# UNITED STATES PATENT AND TRADEMARK OFFICE

APPLICATION NO.	FILING DATE	FIRST NAMED INVENTOR	ATTORNEY DOCKET NO.	CONFIRMATION NO.
10/675,668	09/30/2003	Juan J. Becerra	107044-0012P1	5796
24267	7590	08/03/2006	EXAMINER	
CESARI AND MCKENNA, LLP			ALEJANDRO, RAYMOND	
88 BLACK FALCON AVENUE			ART UNIT	
BOSTON, MA 02210			PAPER NUMBER

## Office Action Summary

**Figure 2** clearly illustrates the fuel container design:

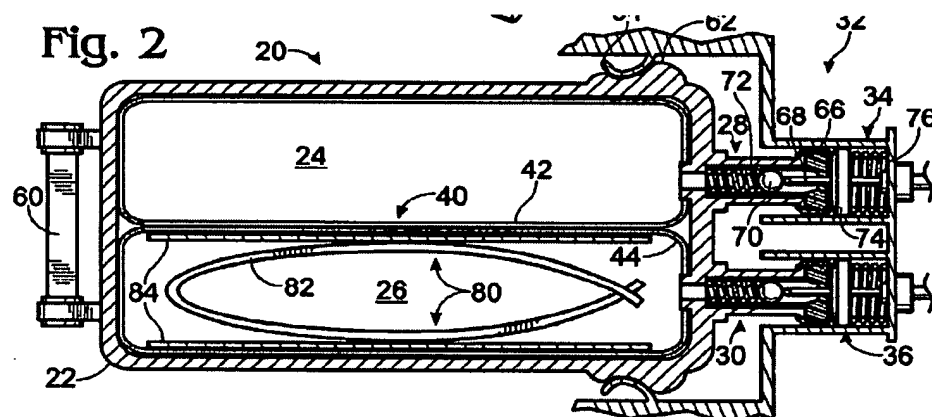
Prasad et al disclose a fuel cell system including a direct methanol fuel cell (P0025, 0045); the fuel cell includes electrode and an electrolyte disposed therebetween (P0002); a fuel supply including fuel storage area 24 configured to hold a fuel solution, a fuel solution outlet 28 configured to pass the fuel solution from the fuel storage area 24; a waste storage area 26, a waste inlet 30 configured to pass waste into the waste storage area 26 and a movable barrier 40

separating the fuel storage area 24 and the waste storage area 26 and configured to move as fuel solution is passed from the area 24 and waste solution is passed into area 26 to simultaneously decrease the volume of area 24 and increase the volume of area 26 (ABSTRACT).

Prasad et al disclose that waste storage area 26 receives waste from the fuel cell (ABSTRACT/P0036). *Thus, it can be asserted that waste storage area 26 receives fuel cell exhaust from both the anode and the cathode.*
